Port of San Francisco
Joint meeting of the
Port of San Francisco
Waterfront Design Advisory Committee
and
Bay Conservation and Development Commission
Design Advisory Committee

Staff Report

Meeting Date: May 5, 2014 – 6:00PM

Re: **Pier 70 Crane Cove Park Master Plan (“Park Master Plan”)**
(see: sfport.com/cranecovepark)

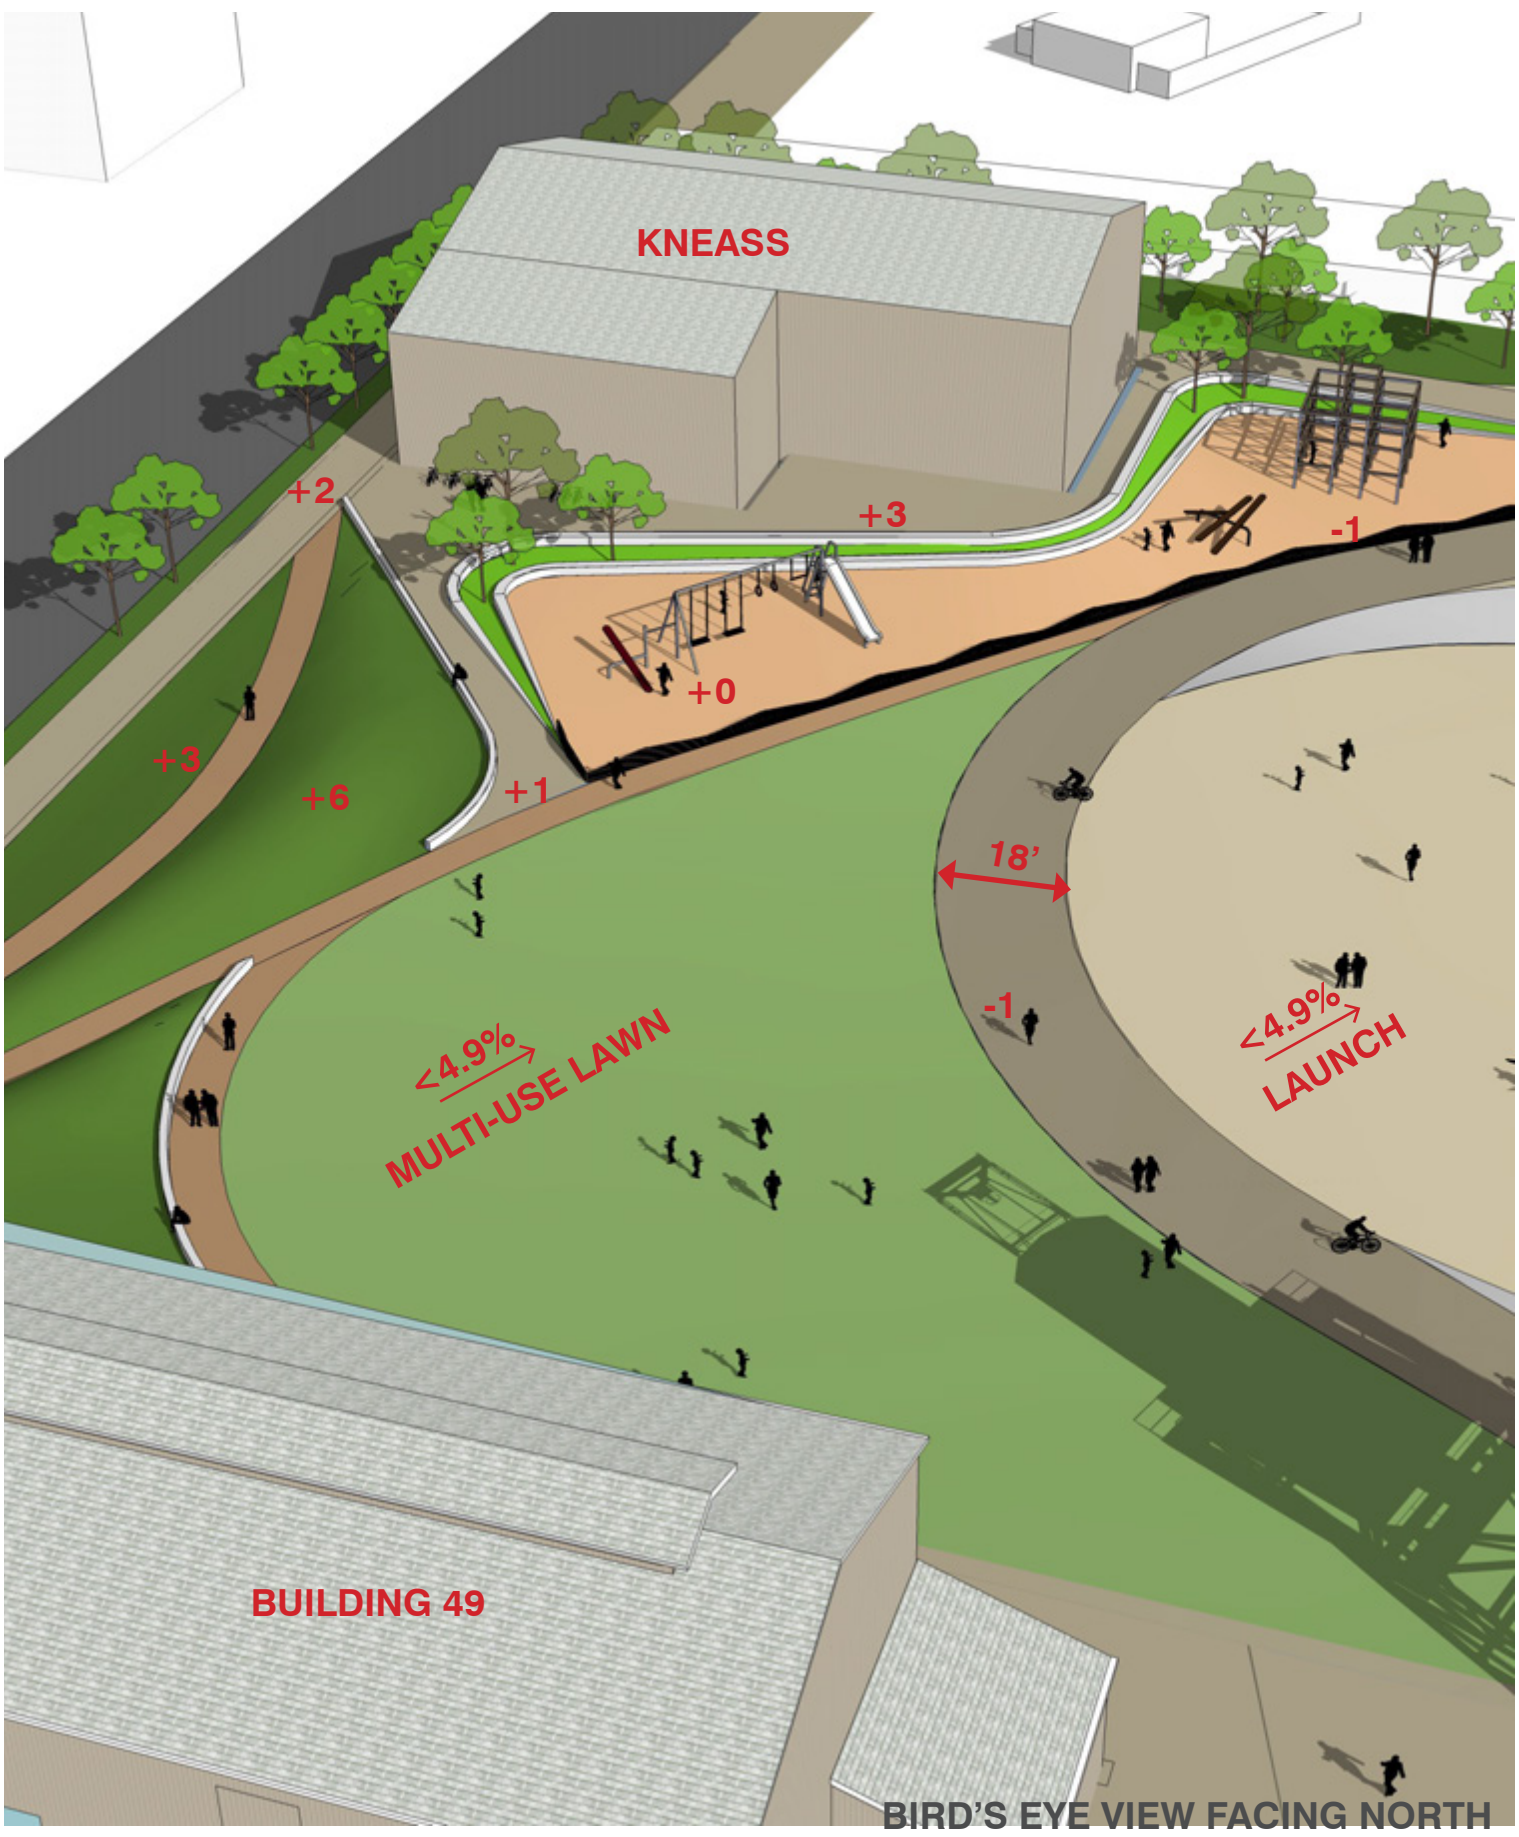
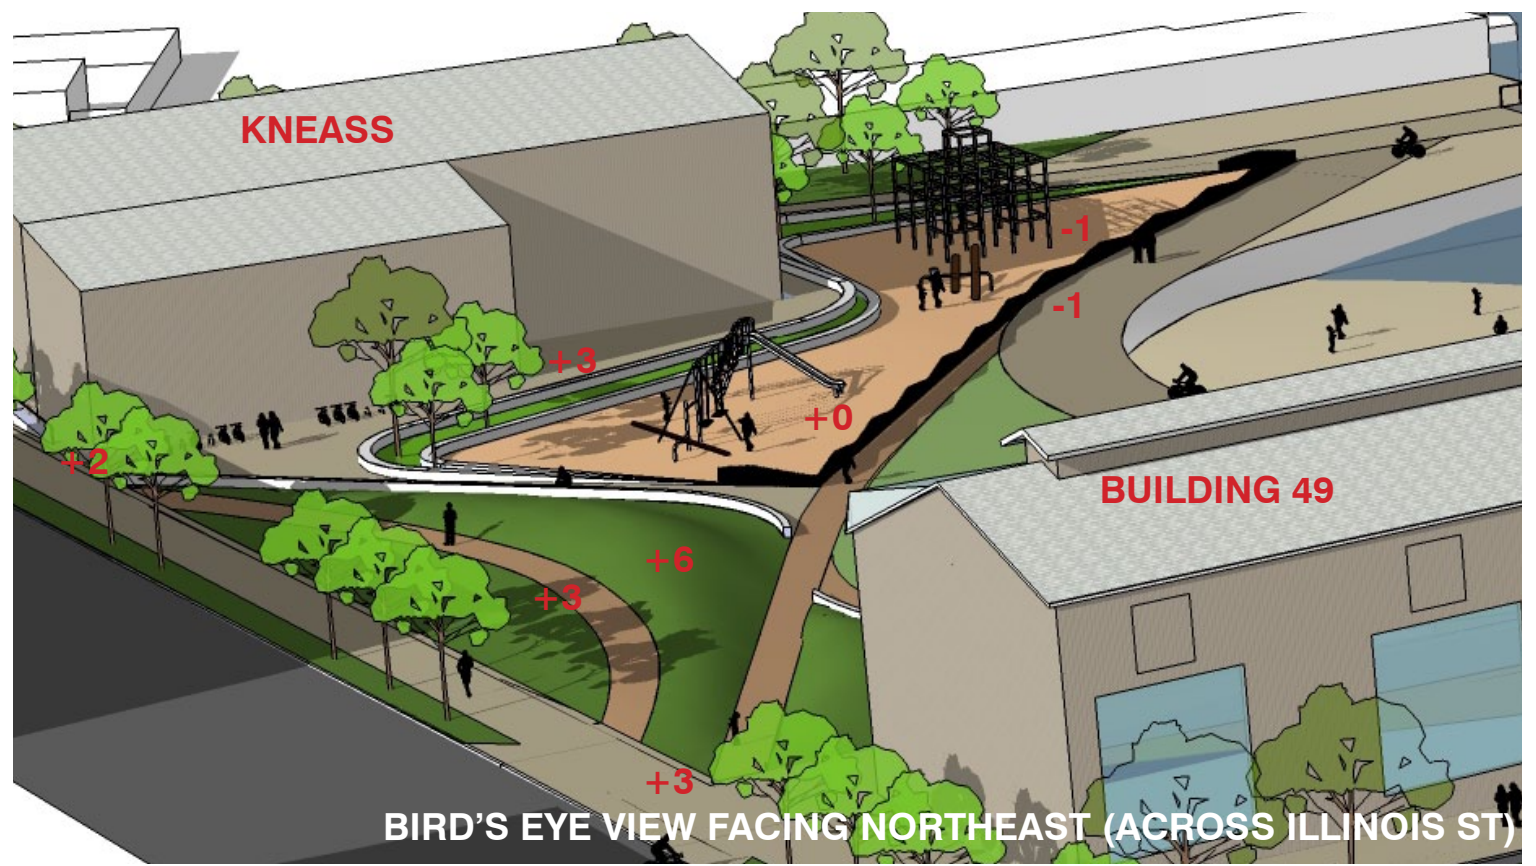
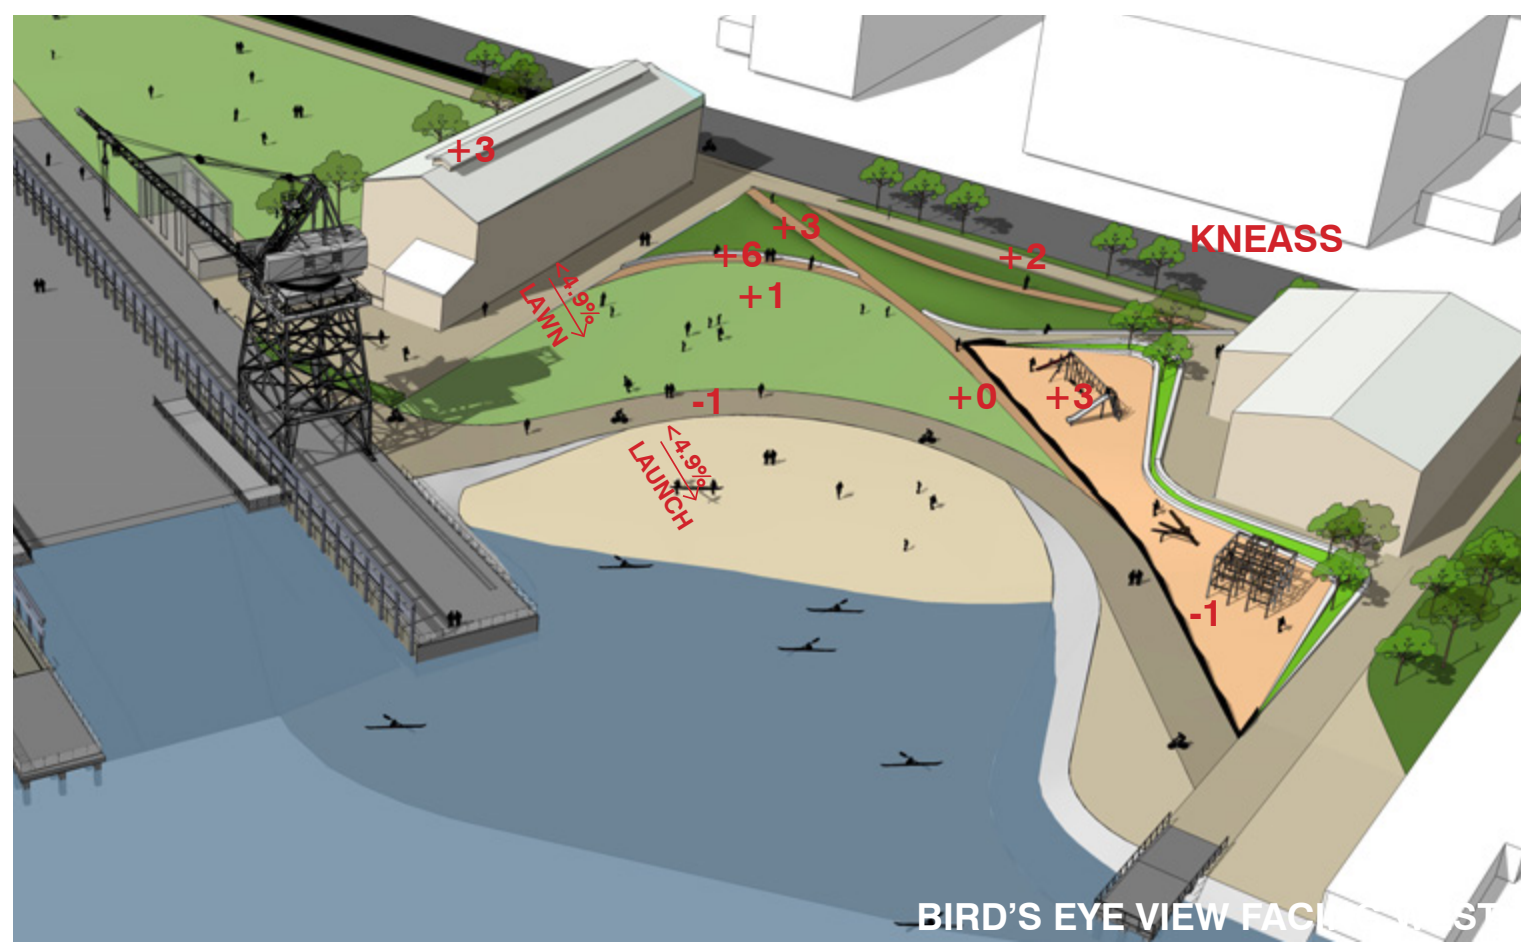
- a. Confirm through coastal engineering analysis that the sandy shoreline can be maintained and that it does not become a muddy shoreline
- b. Can the shoreline design meet accessibility requirements
- c. Confirm that exposure to water and sediment is safe for people
- d. Attempt to orientate beach for easy access from building 49, which a portion of will be used for a human powered boating aquatic center
- e. Determine if the use of rip-rap can be minimized
- f. Clarify the site circulation where pedestrian/ boaters and vehicles overlap on the east end of building 49
- g. Study the planting palette for the area between the sandy shoreline and Illinois Street and if reuse of the building foundation as a landscape wall is appropriate

The northern shoreline includes a variety of program uses (see *Exhibit 5 & 6 Northern Shoreline Schematic Plan and 3 Dimensional Views*), including: the sandy shoreline edge suitable for human powered boating and access into the bay; a new look out pier; a seating area just south of the Ramp Restaurant for the public and as an extension of the restaurant's operations; a shoreline path; a children's play area, a native garden area, a lawn and area for vehicles to drop off/pick up for small water craft.

Since December, the design team has conducted further geotechnical and coastal engineering design and analysis to confirm that a sandy shoreline could be feasible in this area. The coastal conditions were analyzed for sedimentation rates as well as wave, tidal, storm and propeller wash from tug boats that are used in the ship repair operations. Both geotechnical and shoreline conditions accommodate a sandy shoreline edge design with a majority of the sandy area not exceeding a 5% grade to the Mean Low Water elevation. The sandy area has been expanded to the south to improve the relationship to building 49 and the small water craft drop off area. Additionally as a part of the Pier 70 Shoreline sediment investigation and voluntary clean up under the jurisdiction of the Regional Water Quality Control Board, the Port is evaluating appropriate remedial actions to prevent risk to aquatic life and park visitors related to exposure to contaminated bay sediment.

The widened sandy area with increasing slope at its edges has allowed reduction of rip-rap stabilization at the edges. The schematic design also includes a seating area just south of the Ramp Restaurant, and a pier structure that allows over water access and viewing.

A children's play area is sited into a protected area adjacent to the Kneass Building and is nearby to the Ramp restaurant outdoor seating area. The play area is accessed from a secondary pathway off of the primary shoreline path. The shoreline path is 18' wide

A lawn area is located west of the sandy launch area and just north of building 49 and the vehicle drop-off area. The lawn could be used for un-programmed recreation and picnicking, and as a laydown area for boaters. Between the lawn and Illinois Street is a colorful coastal garden area, with its east facing slope planted in no-mow grass. The garden area is elevated to protect Illinois Street from sea level rise, provide a buffer from Illinois Street noise and traffic and is planted utilizing the existing palette found in the site and adjacent neighborhood. The garden area is separated from the lawn with a low wall and secondary walkway.

Just north and east of Building 49 is a vehicle drop-off/pick up area to accommodate small water craft. The vehicle access way would be both a driveway and walkway, anticipating that vehicle use would be minimal and brief. The drop off area accommodates a three-point turn around and can accommodate trailers that transport multiple small water craft. This area is also a transition and circulation point from the slipway 4 and open green area to the northern shoreline area, and includes protections to reduce conflicts between pedestrians and bicyclists and vehicles along the shoreline path.

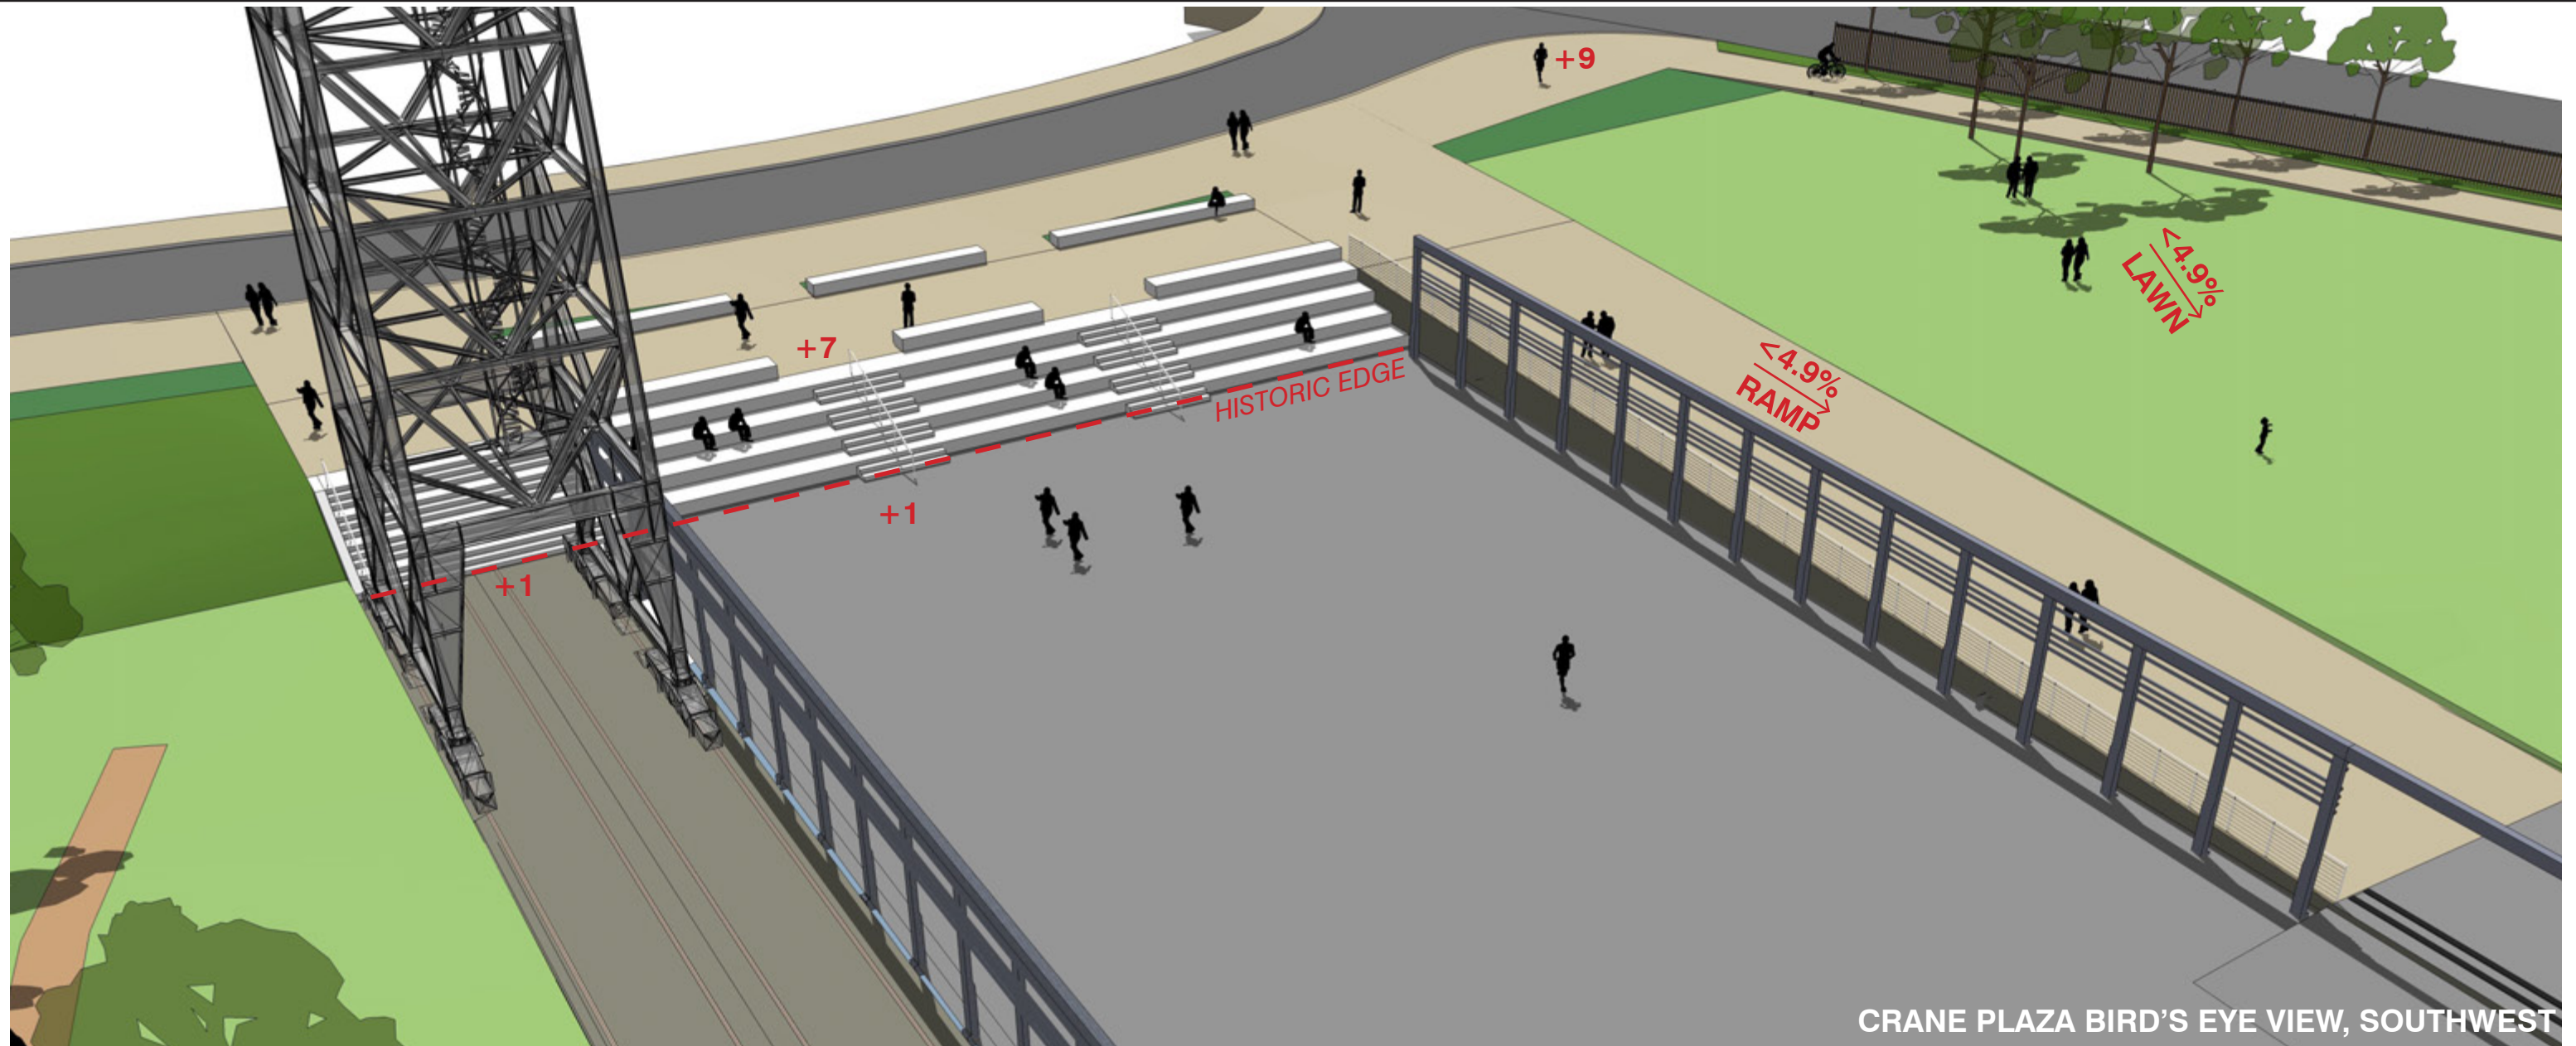
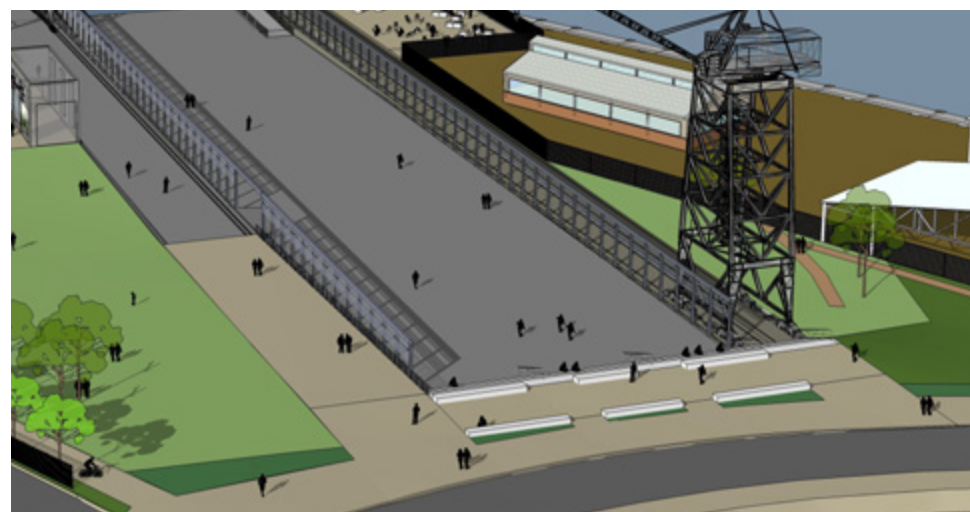
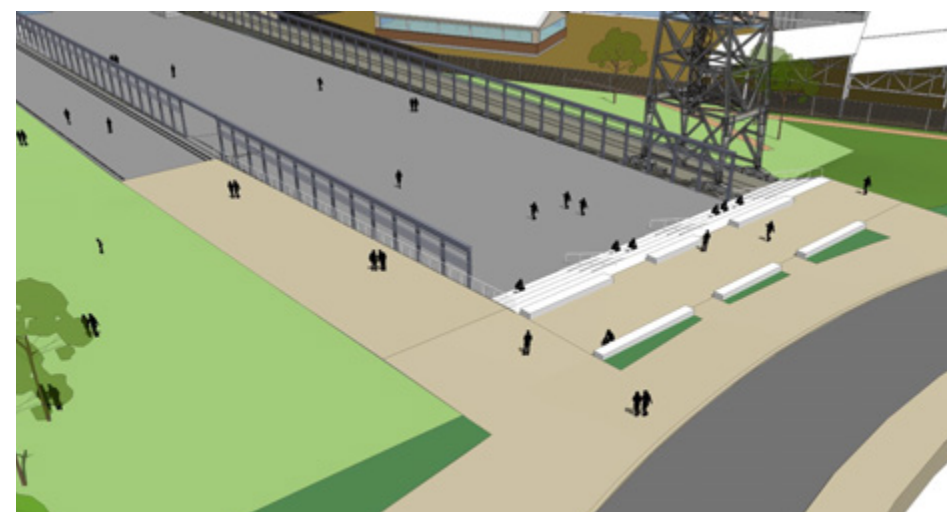
- a) Concern was raised about the narrowness of the 19th street sidewalk and the lack of gathering space within the plaza
- b) Requested further analysis about how lawn area meets 19th and Illinois Street
- c) Suggested that if Illinois Street fence be moved, it should be considered in the context with the existing portion south of 19th street

1. Formal Seating Steps Concept: (see Exhibit 6 & 7, Formal Seating Steps)

This concept utilizes a series of seating and steps as an arrival and termination to slipway 4. The design keeps the profile of 19th Street flat in front of slipway 4 until east of the slipway where it then slopes down to meet existing grade. The new seating and steps are constructed outside the original foot print of the slipway, with the bottom step aligning with the historic terminus of the slipway. The formal seating step concept utilizes the width of the “Way” (ramp) portion of the slipway as a seating area. In addition, a series of planters and seat walls parallel to 19th Street are required to accommodate the cross slope for the width of the Way (100’). The planters and wall provide a buffer between the street and park and help to define bicycle and pedestrian movement. The crane 30 runway on the east side is accessed via steps.

This concept formalizes the terminus of the runway, however to meet Secretary of Interior Standards for the treatment of Historic Resources, the seating steps must read distinctly different than the historic slipway. Materials being considered for improvements in this area include:

- Varying concrete finishes and color, to intentionally make a distinction between the historic slipway and new hardscape;
- The slipway’s concrete Way (ramp) would be repaired and refinished, as would the slipway’s two runways. Both historic elements will have the same concrete color, but will have slightly different finishes;
- The seating and steps of Crane Plaza would have a distinct material and color and finish from that of the historic slipway;
- The sloped walkway along the Crane 14 runway would differ in color and materials from the original runway to be explicit of the fact that it is not a historic element; and
- Concrete pavers are proposed at Crane Plaza, to highlight and accent the plaza as a grand entry into the historic slipway.

In this alternative the entrance to the park at 19th and Illinois street includes a low wall and planter area matching the material and design that runs along the northern side of 19th Street.
